<h2>Product/Process Change Notice (PCN)</h2>	
<input type="checkbox"/> Major Change <input checked="" type="checkbox"/> Minor Change	
PCN Number: PCN_ConUSB3_20250327 Affected Series: ConUSB Affected Part Number: 692121230100 PCN Date: 2024-12-27 (YYYY-MM-DD) Effective Date: 2025-03-27 (YYYY-MM-DD)	Change Category: <input type="checkbox"/> Equipment/Location <input checked="" type="checkbox"/> General Data <input type="checkbox"/> Material <input type="checkbox"/> Process <input type="checkbox"/> Product Design <input type="checkbox"/> Shipping/Packaging <input type="checkbox"/> Supplier <input type="checkbox"/> Software
Contact: Product Management Phone: +49 (0) 7942 - 945 5001 Fax: +49 (0) 7942 - 945 5179 E-Mail: pcn.eican@we-online.com	Datasheet Change: <input checked="" type="checkbox"/> Yes <input type="checkbox"/> No Attachment: <input type="checkbox"/> Yes <input checked="" type="checkbox"/> No

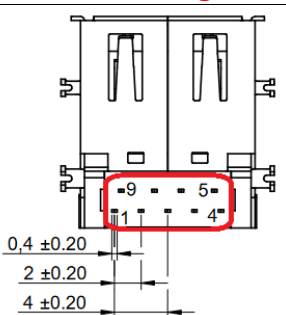
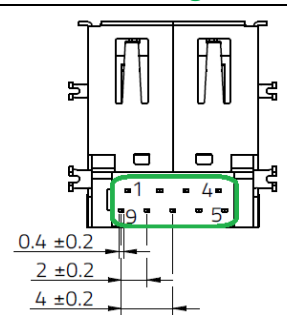
DESCRIPTION OF CHANGE: Because of a database mismatch, Würth Elektronik eiSos will make a correction on the drawing. This is a datasheet correction only. There will be no change in form, fit, function, quality or reliability of the product.	
DETAILS OF CHANGE: The pin number in the drawing are now rearranged correctly.	
Before change 	After change 
RELIABILITY / QUALIFICATION OF CHANGE: There will be no change of electrical & mechanical parameters of the product, therefore no additional reliability or qualification testing was performed.
